**ADDENDUM # 1**

<b>Project</b>	TA Blakelock High School Renovations	<b>Project No.</b>	2215-C
<b>Location</b>	1160 Rebecca Street, Oakville, ON	<b>Date of Issue</b>	2025 04 24
<b>Owner</b>	Halton District School Board	<b>File</b>	2215/7.1.3

This Addendum forms part of the Contract Documents and amends the original Drawings and Specifications, dated 2025 04 17, and all preceding Addenda, as noted below.

3 PARTIAL FLOOR PLAN - LEVEL 0  
A100 1:50

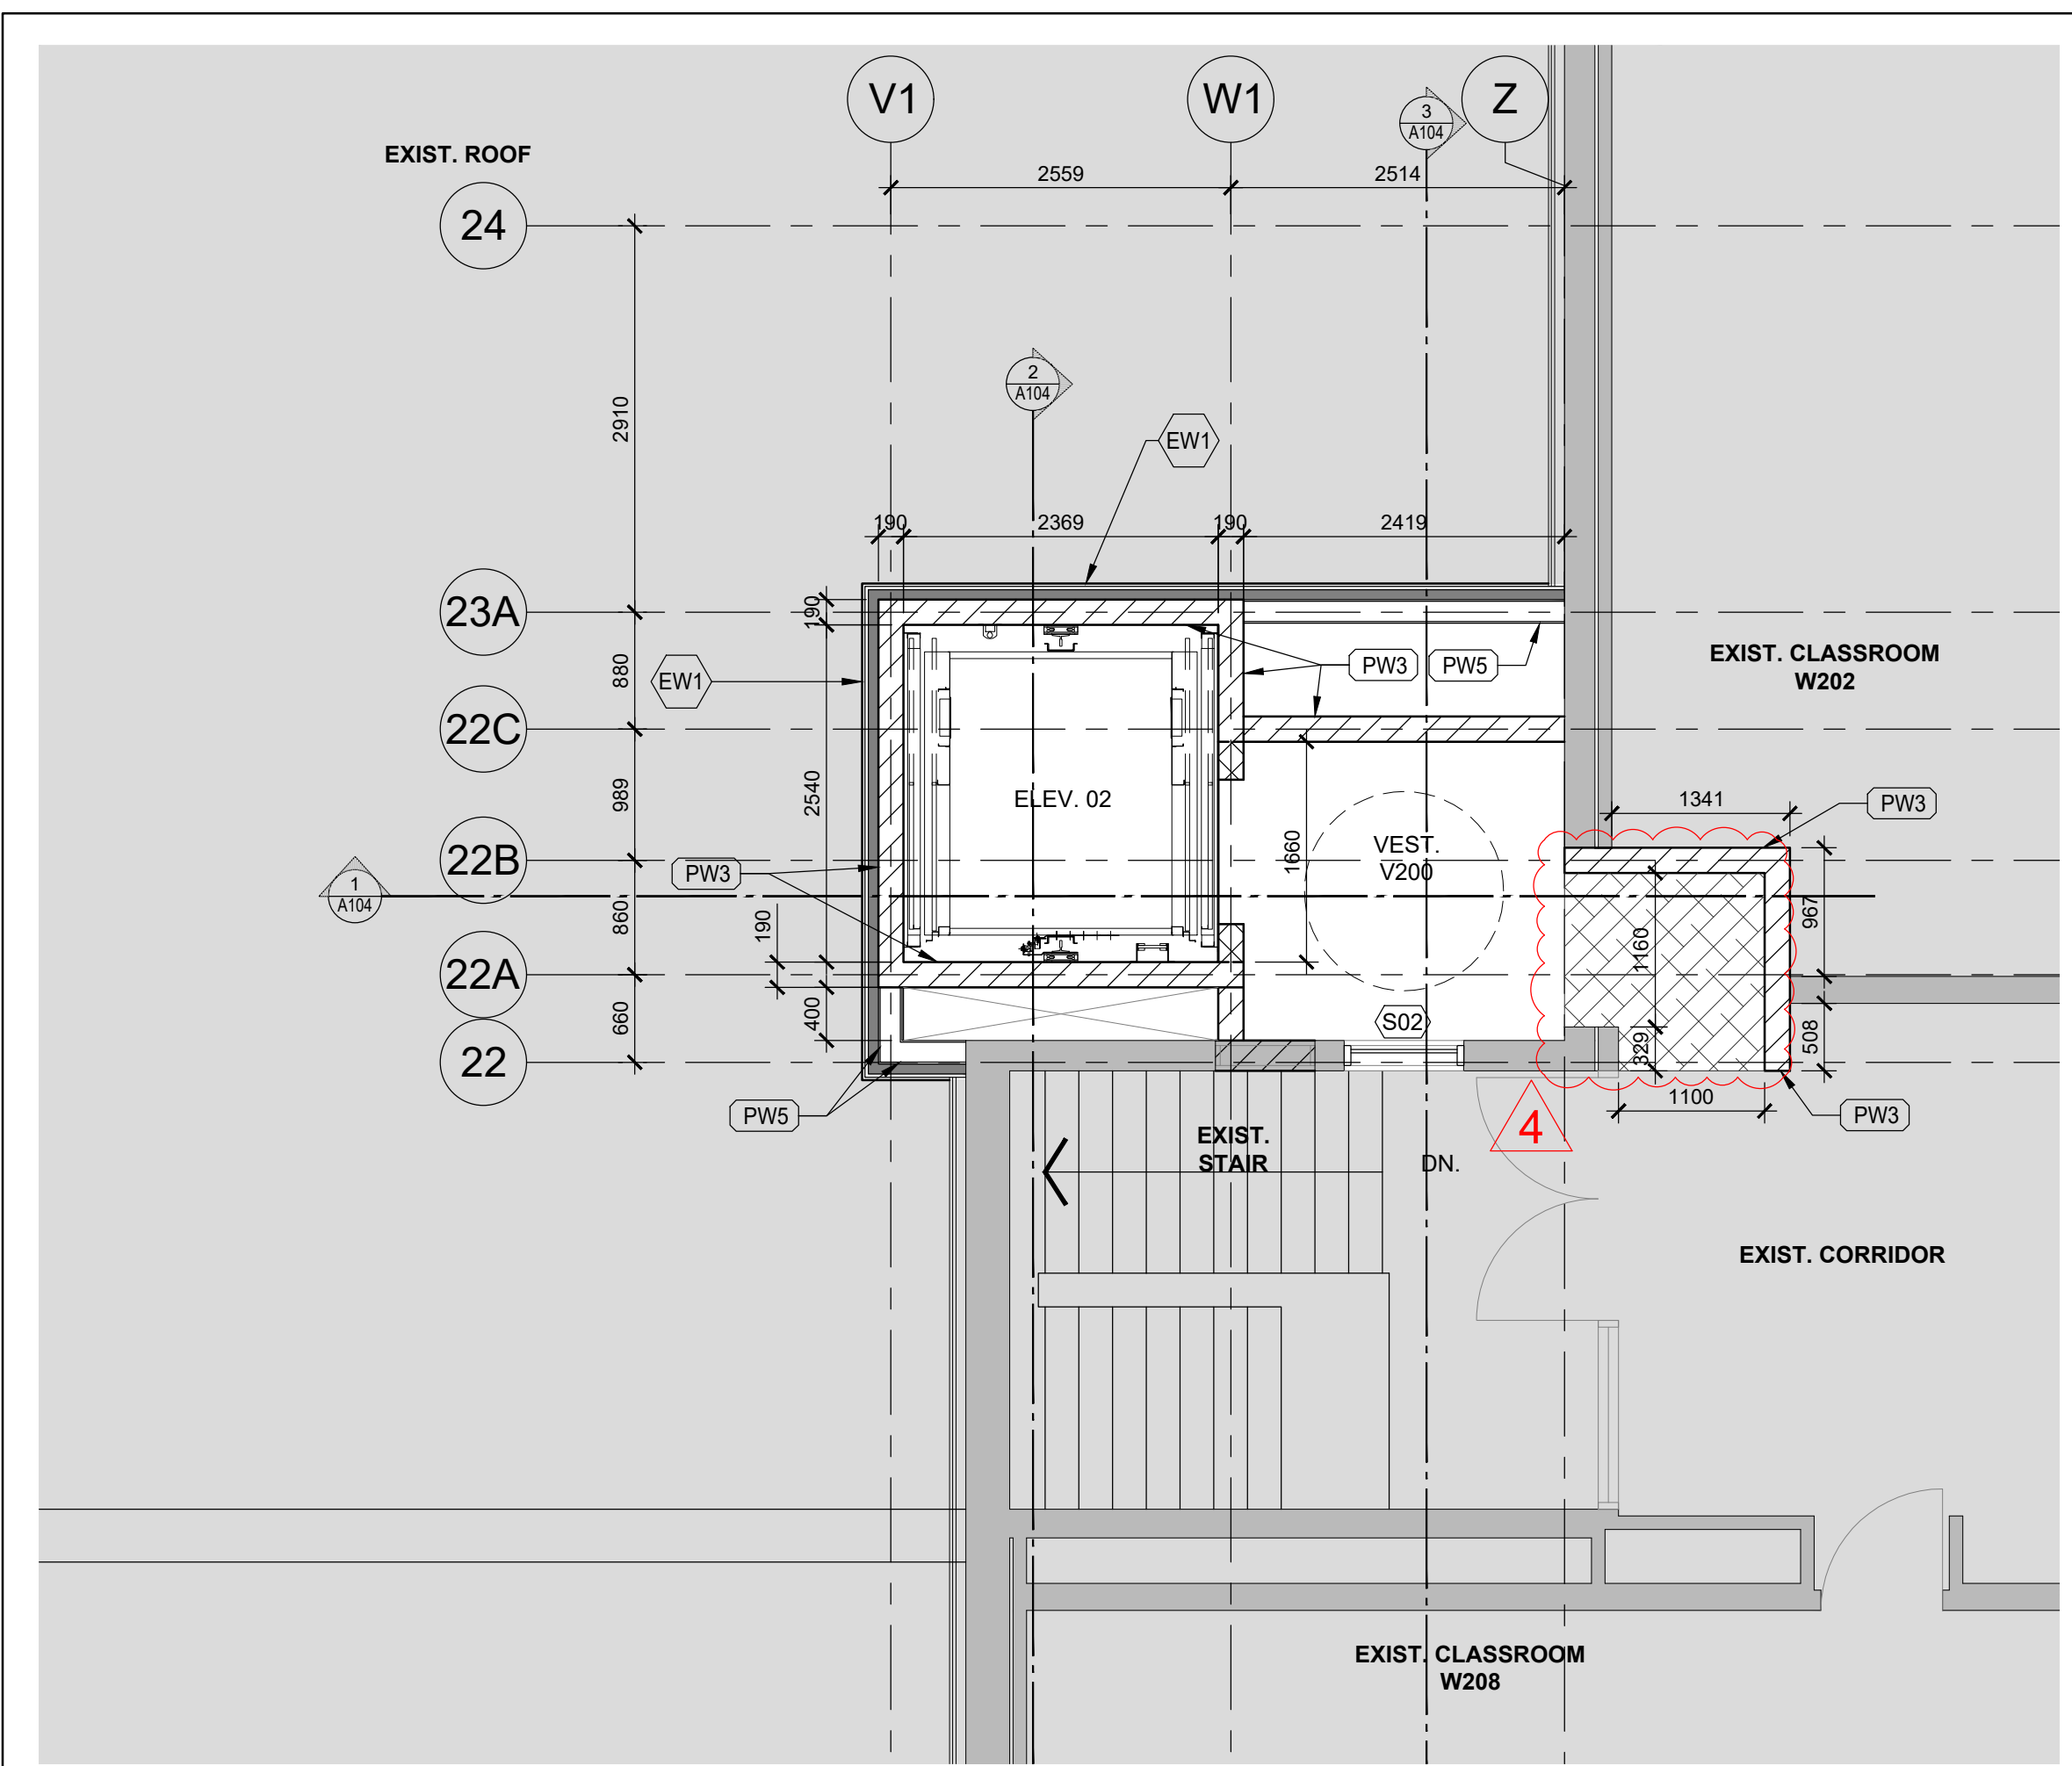
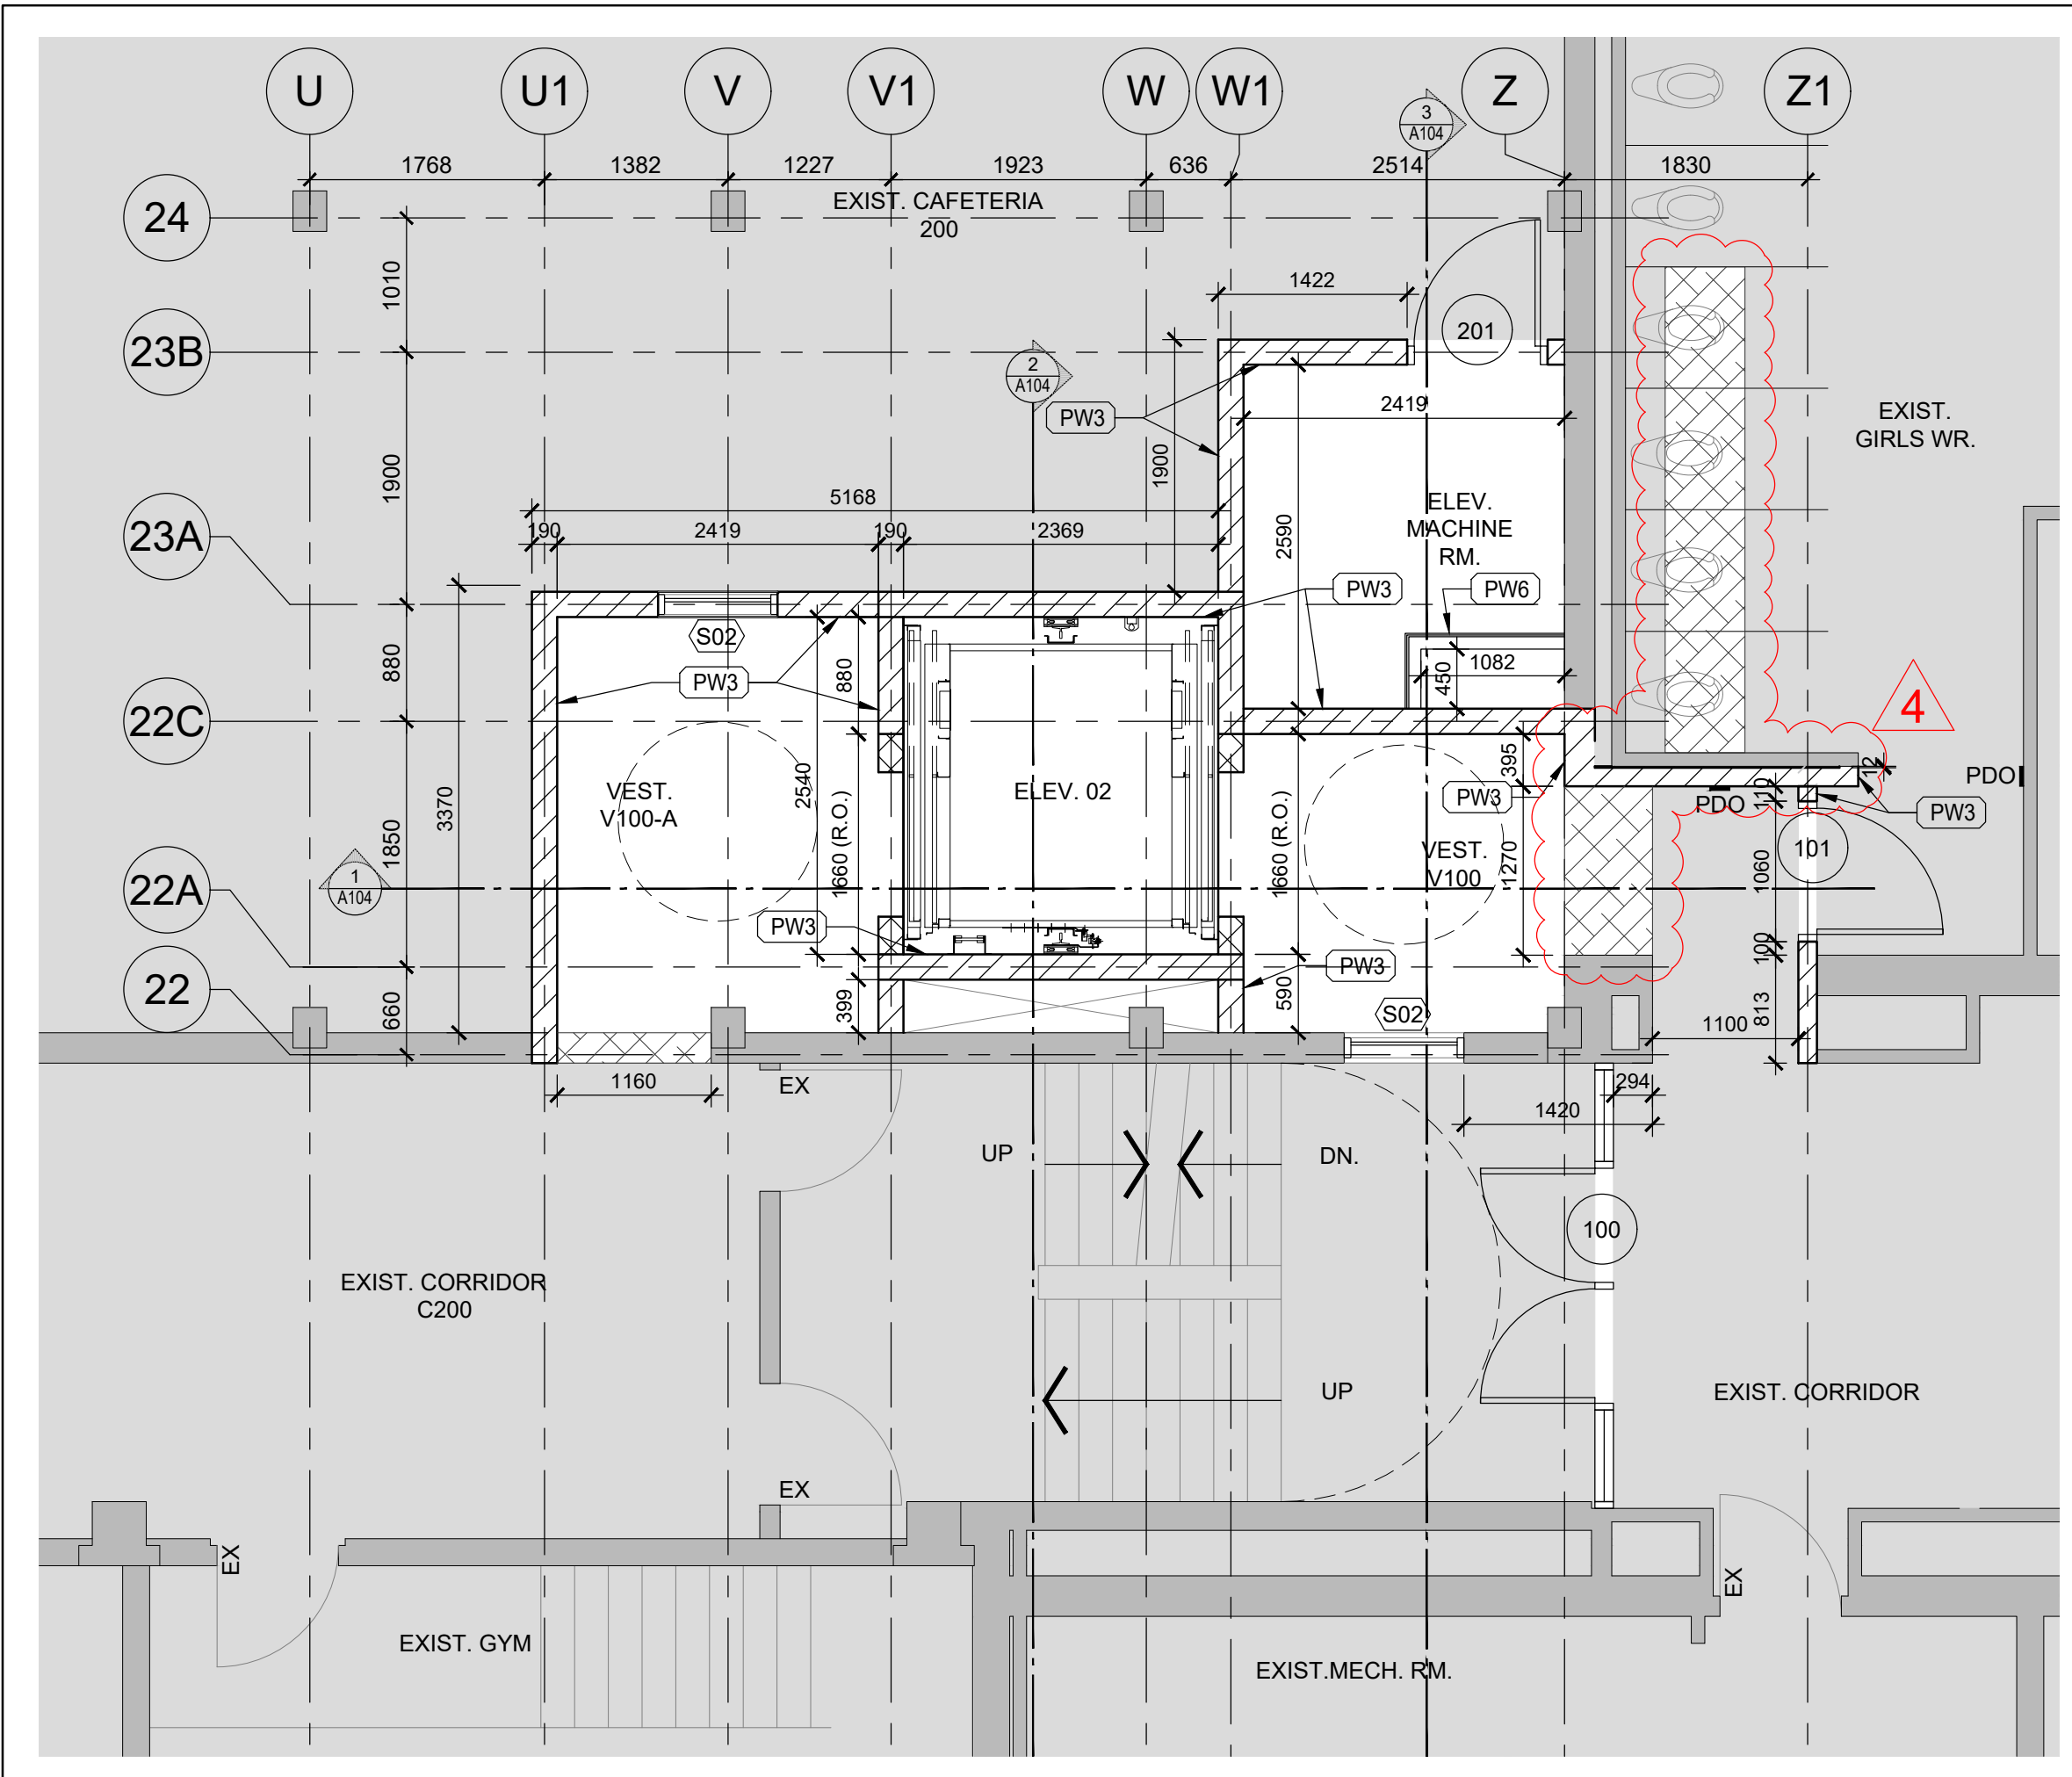
- .1 Replace drawing with the attached Revision No. 4.
- .2 Drawing reissued to clarify scope and include new walls/chase based on coordination with Mechanical and Electrical drawings.
